**RE: 36 WARRY STREET, FORTITUDE VALLEY
RESPONSE TO COUNCIL INFORMATION REQUEST**

DRAWING TITLE: RCV SERVICING

PROJECT TITLE: 36 WARRY ST, FORTITUDE VALLEY

DRAWING NO: 26-076-001	REV: B	SCALE: 1:100 @ A3
CLIENT: LFL PROJECTS	APPROVED BY: CG (RPEQ 34450)

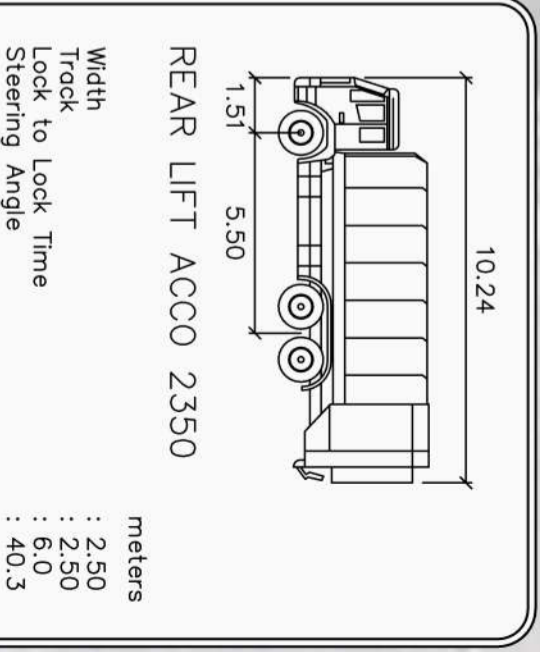
Previously submitted swept paths of a Brisbane City Council (BCC) rear-lift refuse collection vehicle (RCV) have been revised, as requested in Item 10b in BCC's Information Request dated 27 March 2026 (Development Reference: A006963038). The revised RCV swept path is attached and adopts a 9.757 kerb-to-kerb and six second lock-to-lock minimum turning radius, in accordance with BCC Standard Drawing BSD-3008-2. As demonstrated, the proposed access driveway width (ie 6.35m) adequately caters for RCV access/egress and as such, no additional changes to the proposed access design are considered necessary.

REV	DESCRIPTION	CG	DATE
B	IR RESPONSE - UPDATED TURNING RADIUS	CG	06/05/26
A	INITIAL ISSUE	CG	12/12/25
